Tech Max Ltd.

Building Information

Observations

1) 1st floor load plan. 2) 2nd floor load plan

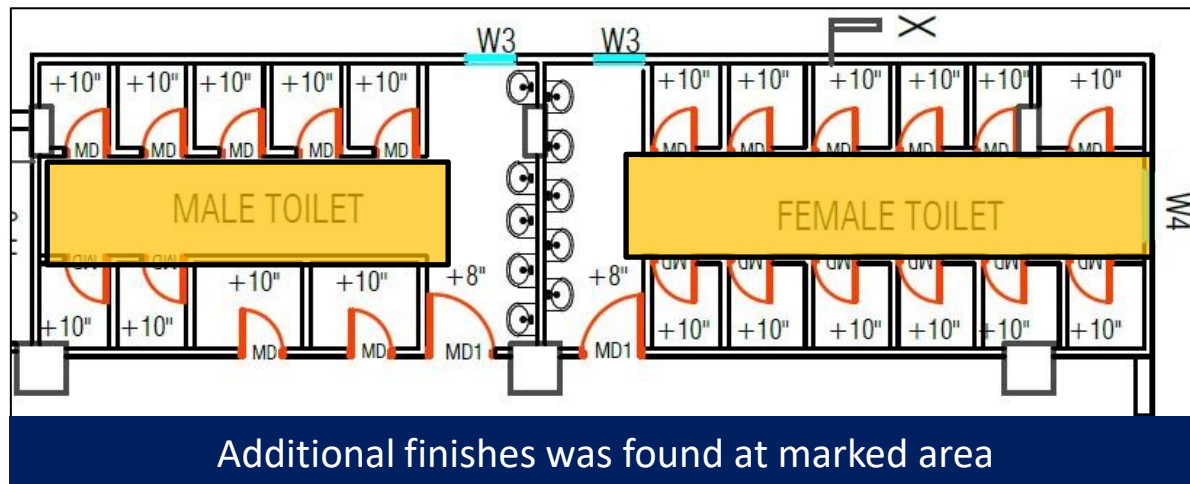
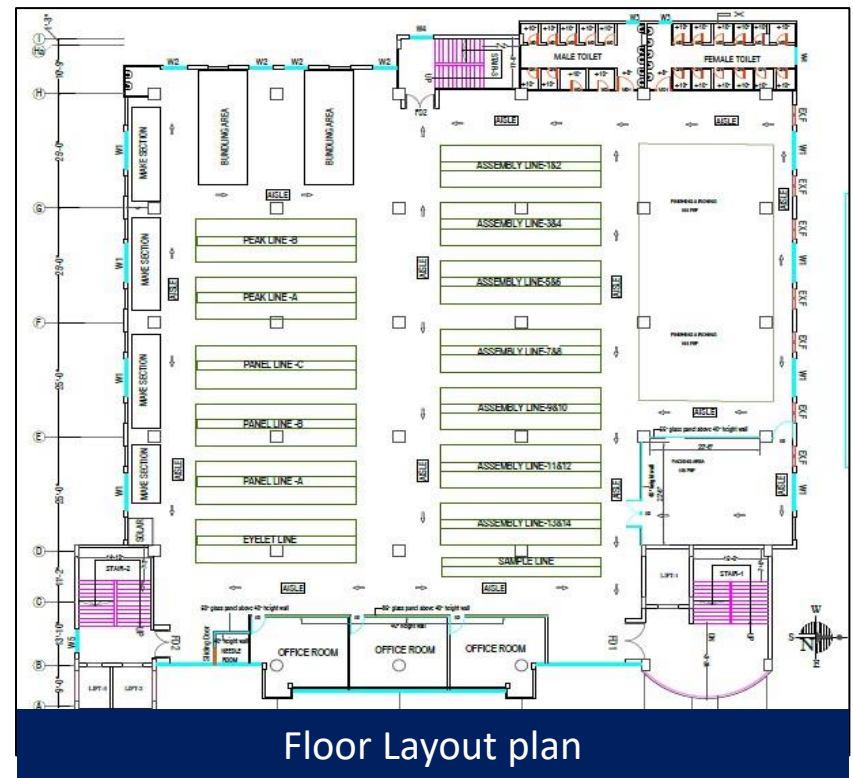
Live load has been considered 5 kPa (105 psf) in load plan.

The live load of the storage area has been considered 5kPa (105 psf) which do not comply the floor load requirement of BNBC. As per BNBC, minimum loading 6 Kpa is required for the light storage warehouse. Building engineer is required to update the floor loading plan, software-based analysis and design report following BNBC loading requirement.

Ferro Scan

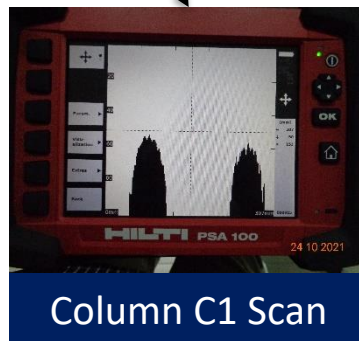
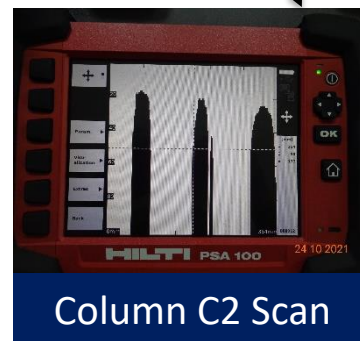
As-built drawing no. of rebar of C1, C2 & C3 column was mentioned as 8-20mm, 10-20mm & 12-20mm, respectively. But during the inspection by Ferro scanning no. of rebar of C1, C2 & C3 column was found 4-20mm, 8-20mm & 8-20mm, respectively. Building engineer is required to update the as-built drawing with the accurate on-site condition.

Dampness on brick wall

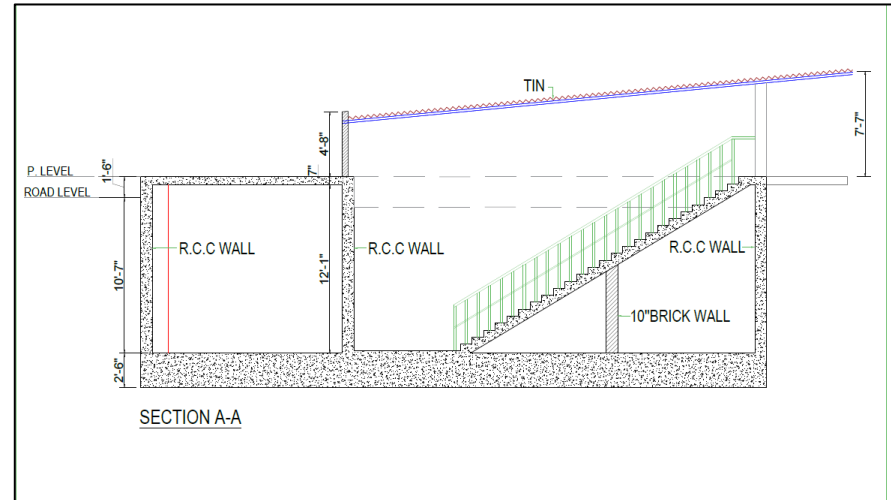
Due to water absorption, dampness was found on brick wall & RC beam. Building engineer is required to take necessary measures to prevent dampness in brick wall & RC beam.
